June/July 2022 | Danfoss Climate Solutions for cooling

TECH
INSIDER

VZH170 New Models with R410A/R452B/R454B

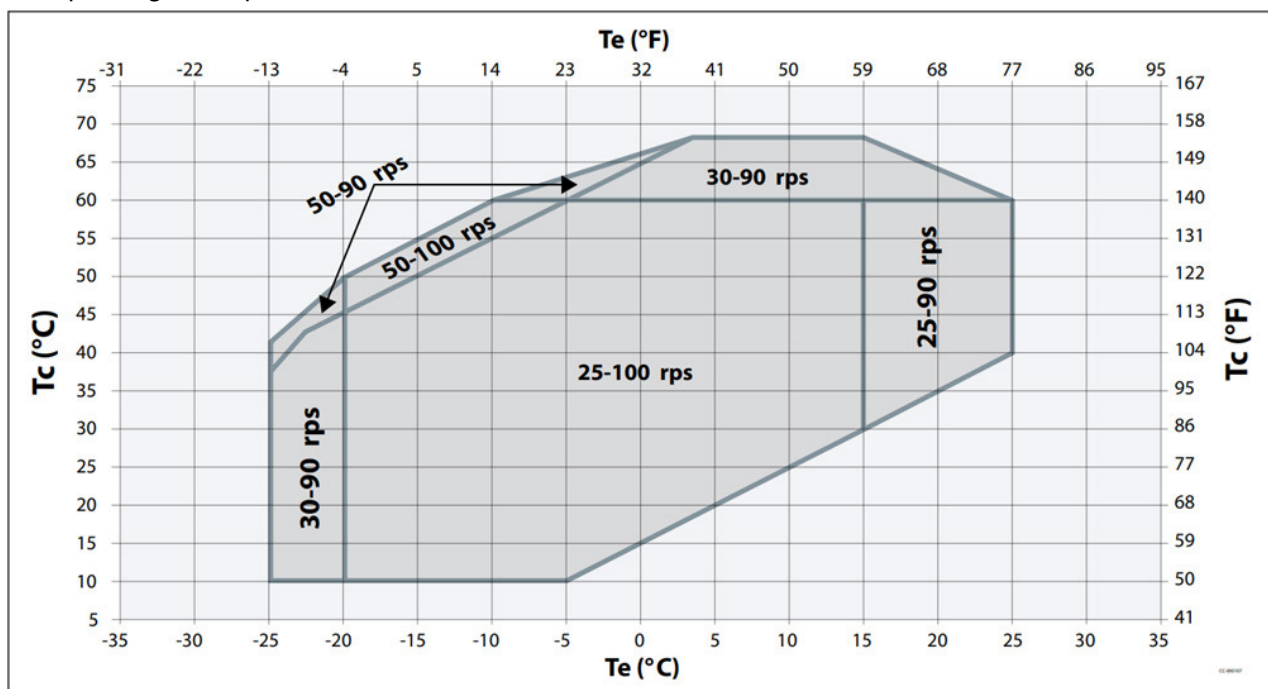
Danfoss has released new variable speed compressor **VZH170 models** after VZH088/117 which can be used with multiple refrigerants: R410A, R452B, and R454B.

The new models with R410A/R452B/R454B are currently limited to code G (400 V, 3-phase).

R452B and R454B are HFO/HFC blends with similar capacities to R410A. Due to their limited discharge temperature difference, they are currently the best candidate for a direct drop-in replacement for R410A. And although R452B and R454B are classified A2L, it is considered the least flammable of all the leading R410A replacements.
